V2500-A5/D5 PROPULSION SYSTEMS SERVICE BULLETIN

V2500-ENG-73-0176

ENGINE – FUEL AND CONTROL – TRW LUCAS AEROSPACE FUEL METERING UNIT (FMU) – REWORK
INSTRUCTION FOR MACHINING THE MAIN METERING VALVE PLUNGER INSTALLED IN THE FMU 530,
540 AND 550 UNITS

Main Metering Valve Plunger Re-work Detail

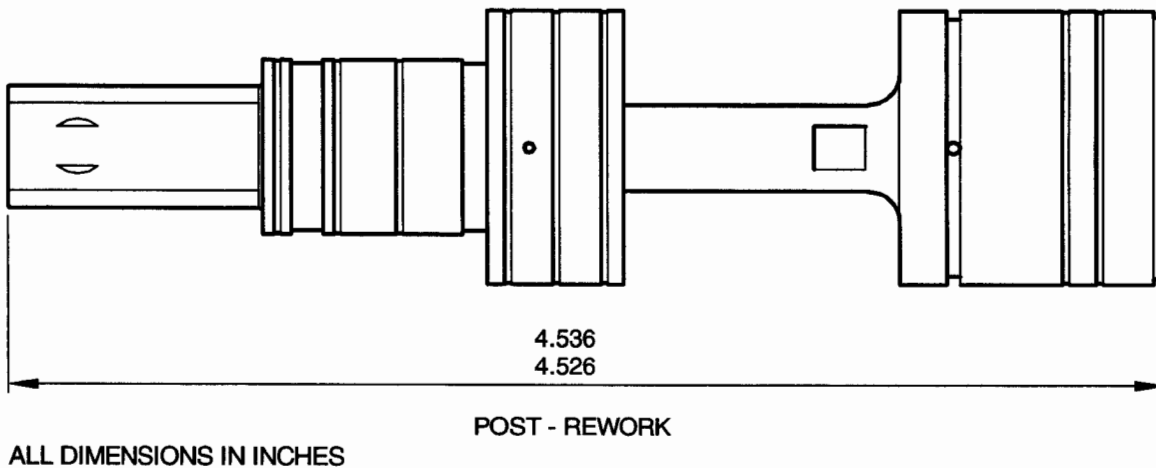
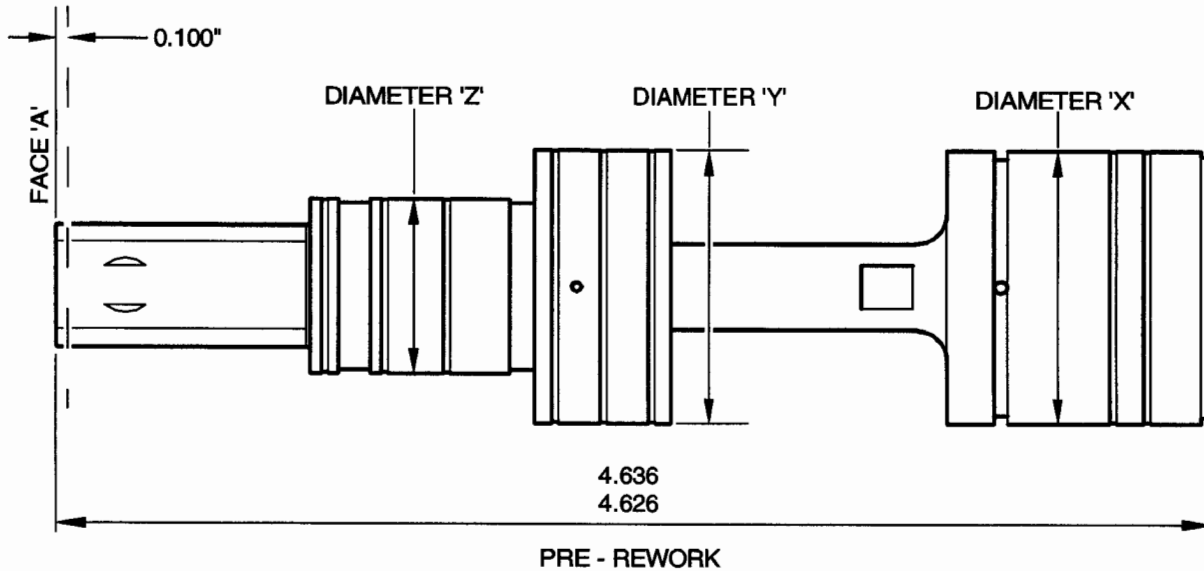
The Main Metering Valve (MMV) Plunger is 0.100 in. (2,54 mm) longer in overall length than the drawing nominal dimension. The increase in length is the result of a machining process omission during original manufacture.

CAUTION: IT IS ESSENTIAL THAT THE PROCESS USED TO SET UP THE PLUNGER FOR GRINDING DOES NOT RESULT IN DISTORTION OF THE PLUNGER OR DAMAGE TO THE MATED SURFACES REF. 'X', 'Y' AND 'Z' FIG 1.

- (3) Position the plunger at 90 degrees to the traverse of the grinding wheel.
- (4) Surface grind the end face, adjacent to the rack location, ref. Face 'A' Fig 1, and reduce the overall dimension to the drawing limits of between 4.536 in. to 4.526 in. (115,214 mm to 114,960 mm).
- (5) Remove the plunger from the grinding machine.
- (6) Deburr the machined edges, keep the sharp definition.
- (7) Clean the plunger, ref. CMM FMU 530, 73-28-02, CLEANING, Page Block 401 to 499.
- (8) Carefully examine the plunger for remaining grinding swarf. Make sure that all the swarf has been cleaned from the holes and drillings.
- (9) Install the rack and the pin into the plunger, ref. CMM FMU 530, 73-28-02, ASSEMBLY, Page Block 701 to 799.
- (10) Install the plunger into the sleeve and install the assembly into the FMU, ref. CMM FMU 530, 73-28-02, ASSEMBLY, Page Block 701 to 799.

Main Metering Valve Plunger Re-work Detail
Figure 1

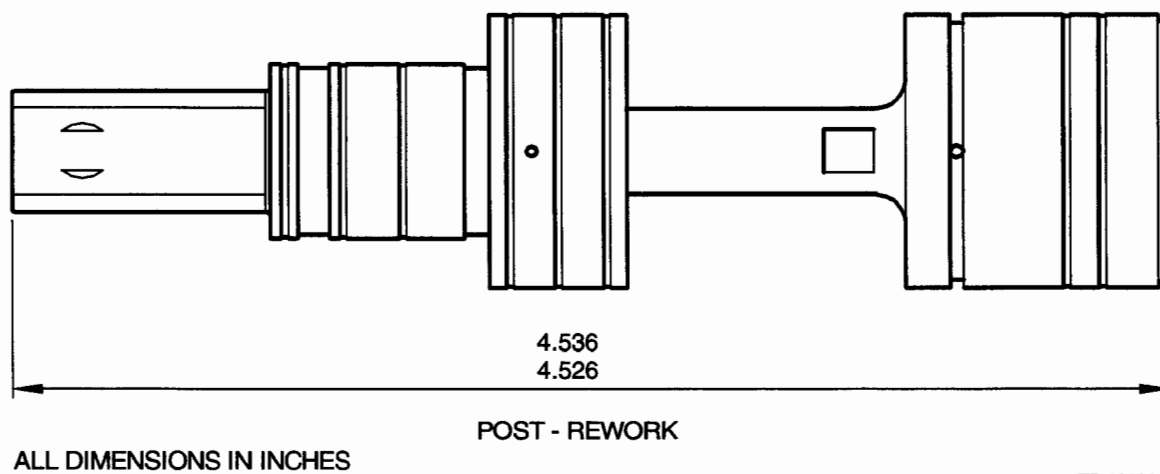
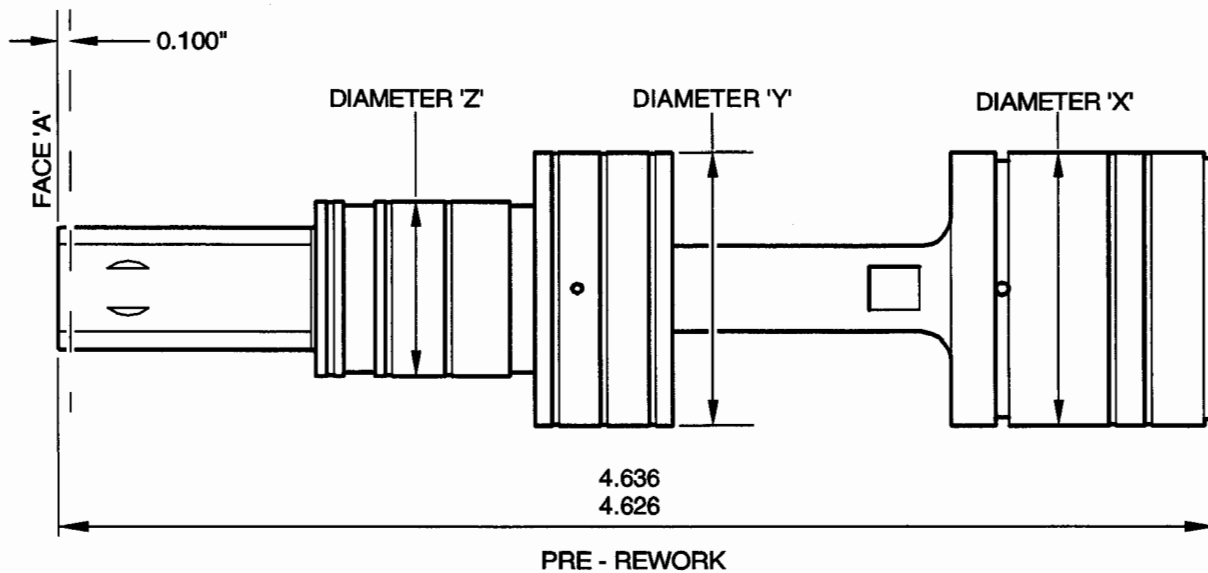
The Main Metering Valve (MMV) Plunger is 0.100 in. (2,54 mm) longer in overall length than the drawing nominal dimension. The increase in length is the result of a machining process omission during original manufacture.

CAUTION: IT IS ESSENTIAL THAT THE PROCESS USED TO SET UP THE PLUNGER FOR GRINDING DOES NOT RESULT IN DISTORTION OF THE PLUNGER OR DAMAGE TO THE MATED SURFACES REF. 'X', 'Y' AND 'Z' FIG 1.

- (3) Position the plunger at 90 degrees to the traverse of the grinding wheel.
- (4) Surface grind the end face, adjacent to the rack location, ref. Face 'A' Fig 1, and reduce the overall dimension to the drawing limits of between 4.536 in. to 4.526 in. (115,214 mm to 114,960 mm).
- (5) Remove the plunger from the grinding machine.
- (6) Deburr the machined edges, keep the sharp definition.
- (7) Clean the plunger, ref. CMM FMU 540, 73-28-07, CLEANING, Page Block 401 to 499.
- (8) Carefully examine the plunger for remaining grinding swarf. Make sure that all the swarf has been cleaned from the holes and drillings.
- (9) Install the rack and the pin into the plunger, ref. CMM FMU 540, 73-28-07, ASSEMBLY, Page Block 701 to 799.
- (10) Install the plunger into the sleeve and install the assembly into the FMU, ref. CMM FMU 540, 73-28-07, ASSEMBLY, Page Block 701 to 799.

Main Metering Valve Plunger Re-work Detail
Figure 1

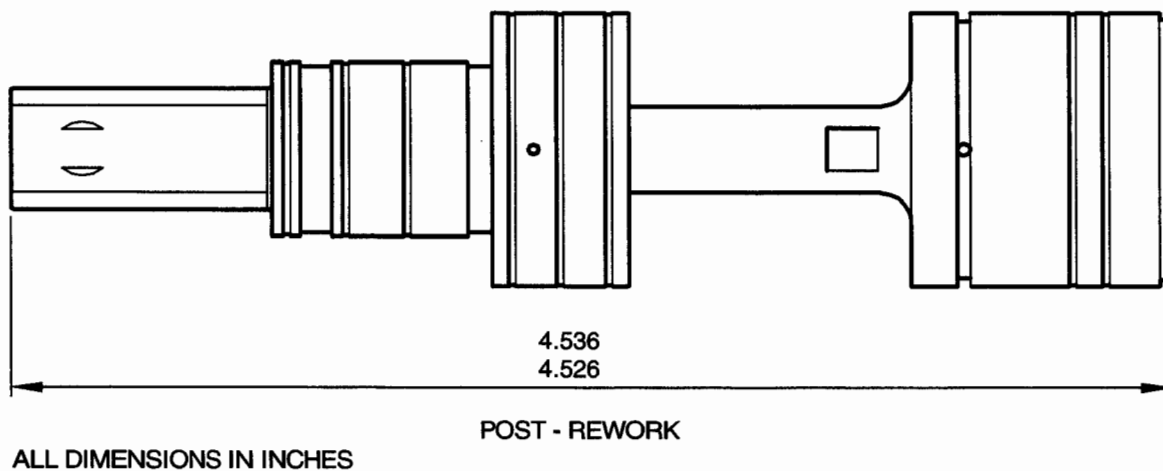
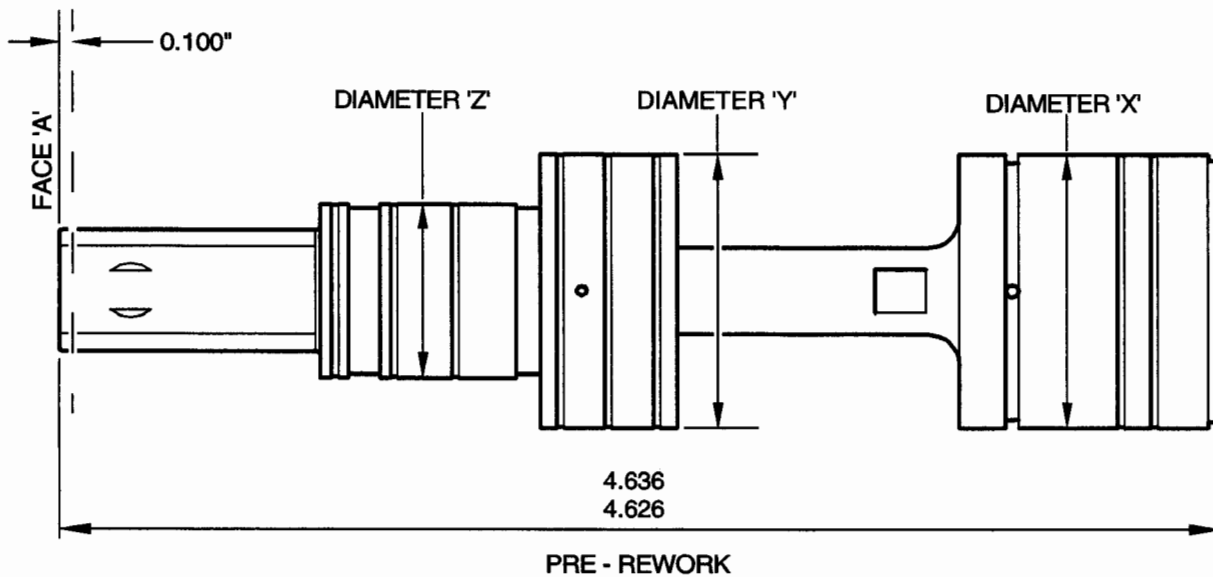
The Main Metering Valve (MMV) Plunger is 0.100 in. (2,54 mm) longer in overall length than the drawing nominal dimension. The increase in length is the result of a machining process omission during original manufacture.

CAUTION: IT IS ESSENTIAL THAT THE PROCESS USED TO SET UP THE PLUNGER FOR GRINDING DOES NOT RESULT IN DISTORTION OF THE PLUNGER OR DAMAGE TO THE MATED SURFACES REF. 'X', 'Y' AND 'Z' FIG 1.

- (3) Position the plunger at 90 degrees to the traverse of the grinding wheel.
- (4) Surface grind the end face, adjacent to the rack location, ref. Face 'A' Fig 1, and reduce the overall dimension to the drawing limits of between 4.536 in. to 4.526 in. (115,214 mm to 114,960 mm).
- (5) Remove the plunger from the grinding machine.
- (6) Deburr the machined edges, keep the sharp definition.
- (7) Clean the plunger, ref. CMM FMU 550, 73-28-08, CLEANING, Page Block 401 to 499.
- (8) Carefully examine the plunger for remaining grinding swarf. Make sure that all the swarf has been cleaned from the holes and drillings.
- (9) Install the rack and the pin into the plunger, ref. CMM FMU 550, 73-28-08, ASSEMBLY, Page Block 701 to 799.
- (10) Install the plunger into the sleeve and install the assembly into the FMU, ref. CMM FMU 550, 73-28-08, ASSEMBLY, Page Block 701 to 799.
